Access Compliance Report

Public Rights-of-Way

Intersection ID: 30497	Main Street: STONES_LANDING_ST	Cross Street: WALKING_STICK_DR	Location: SW
ADA ID: E2ED0C9D4053	Ramp Type: BlendTrans1	Initial Pass/Fail: Fail	Overall Compliance: No
		Severity Score: 10

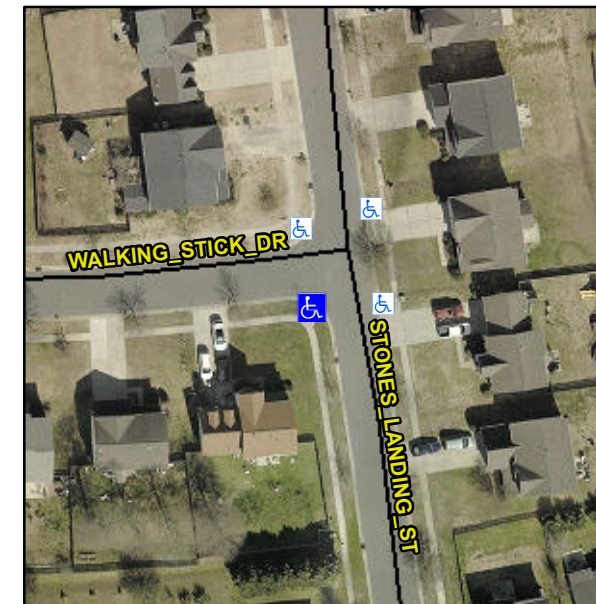
R304.5.1, R304.5.3

Compliance	Description	Data	Compliance	Description	Data
N/A	Ramp Length (in)	85.0	Yes	BlendTrans Slope (%)	3.9
No	Ramp Width (in)	45.5	No	BlendTrans XSlope (%)	3.4
N/A	Flare Type LT	N/A	N/A	Flare Type RT	N/A
N/A	Flare Slope LT (%)	N/A	N/A	Flare Slope RT (%)	N/A
N/A	Flare Traversable LT?	N/A	N/A	Flare Traversable RT?	N/A
N/A	Landing Length (in)	N/A	N/A	DWS Provided?	N/A
N/A	Landing Width (in)	N/A	N/A	DWS Contrast?	N/A
N/A	Landing Slope (%)	N/A	N/A	DWS Length (in)	N/A
N/A	Landing X Slope (%)	N/A	N/A	DWS Full Width?	N/A
N/A	Landing Curb? (Y/N)	N/A	N/A	DWS Offset (in)	N/A
N/A	Shared Landing?	N/A			
N/A	Gutter Ponding?	N/A	N/A	Gutter Slope (%)	N/A
N/A	Gutter Lip Ht (in)	N/A	N/A	Gutter X Slope (%)	N/A
N/A	Painted X Walk1?	No	N/A	Painted X Walk2?	No
	X Walk 1 Direction	To E		X Walk 2 Direction	To N
	X Walk 1 Width (in)	N/A		X Walk 2 Width (in)	N/A
	X Walk 1 Slope (%)	1.4		X Walk 2 Slope (%)	1.7
	X Walk 1 X Slope (%)	1.2		X Walk 2 X Slope (%)	0.3

Remove & Replace Curb Ramp With Two New Directional Ramps or Equivalent.
